**Florissant Road Street Improvements STP 5583(607)**  
WDG No. 9703-20-4

**ADDENDUM #1**

Date: November 16<sup>th</sup>, 2021

**PLAN & PROFILE SHEET**

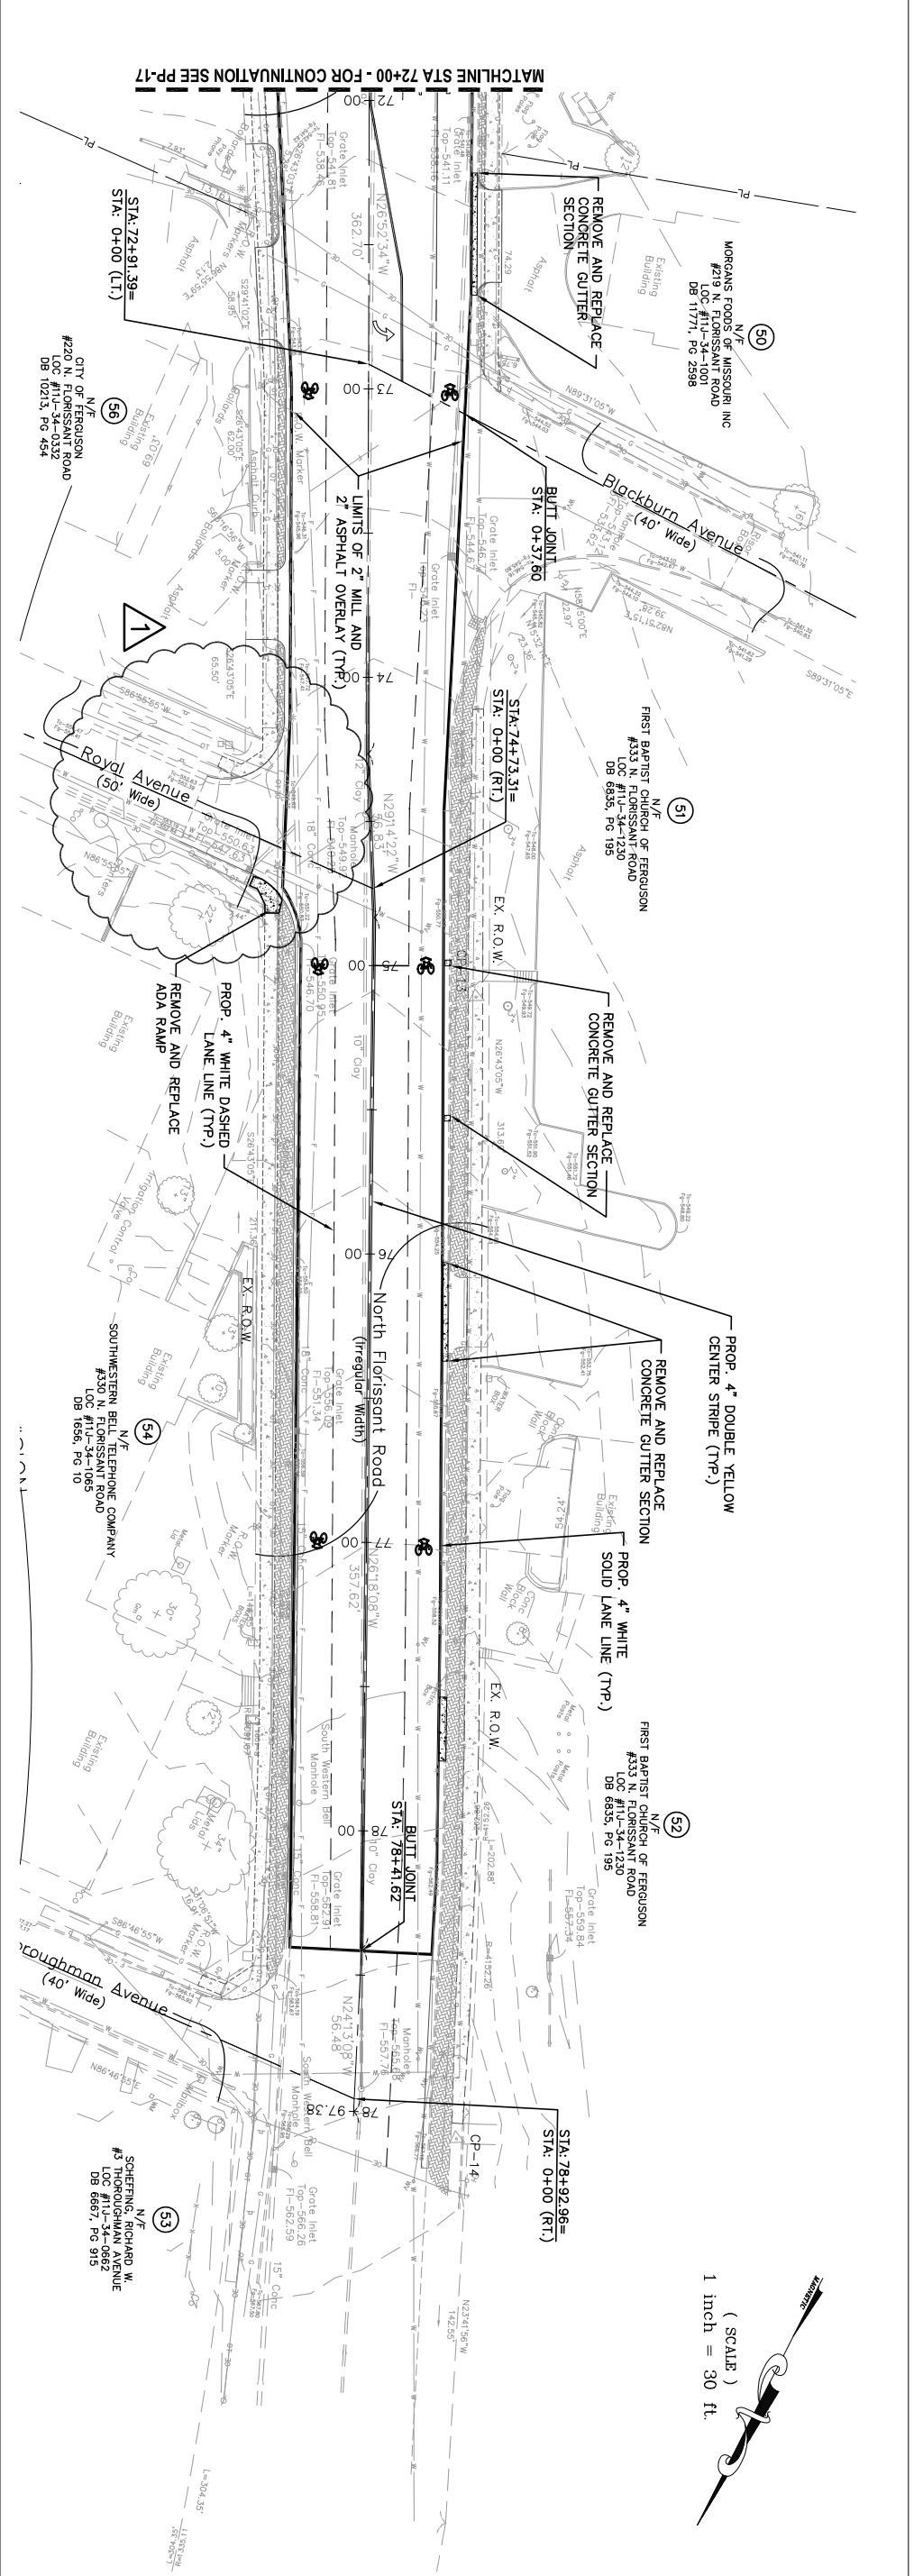
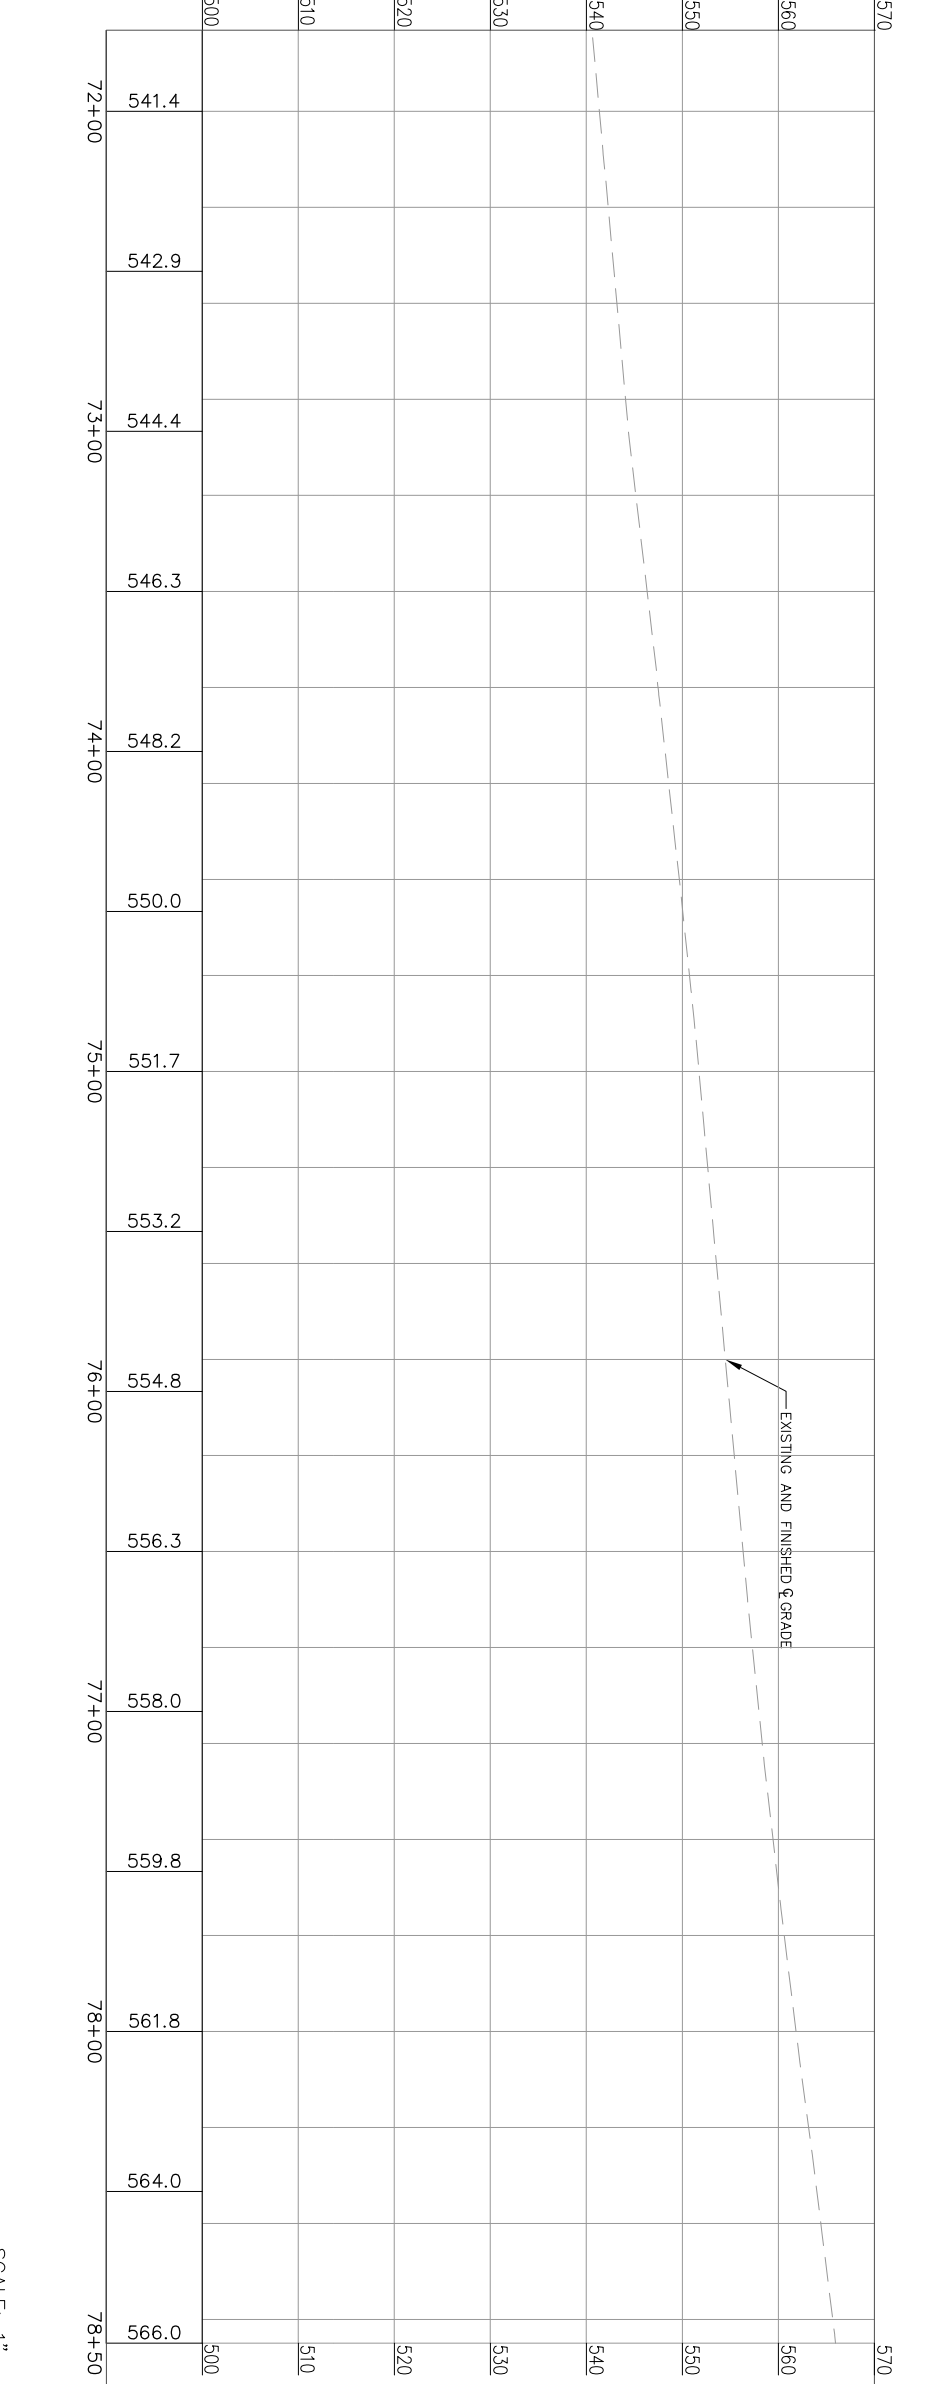
- Bid Specifications:
  - a. Letting date will be changed to December 10<sup>th</sup> 2021.
  - b. On Attachment A, Line Item for detector loops to be removed and replaced with the unit of measurement being per EACH.
- Bid Plans:
  - a. Eliminate Butt Joint at Royal Avenue. Milling to be reduced to just the North Florissant Road area. This can be found on Sheet 3.9

| REVISIONS  |   |
|------------|---|
| 11/16/2021 | ADDENDUM #1 - ELIMINATE MILLING AT ROYAL AVE. |
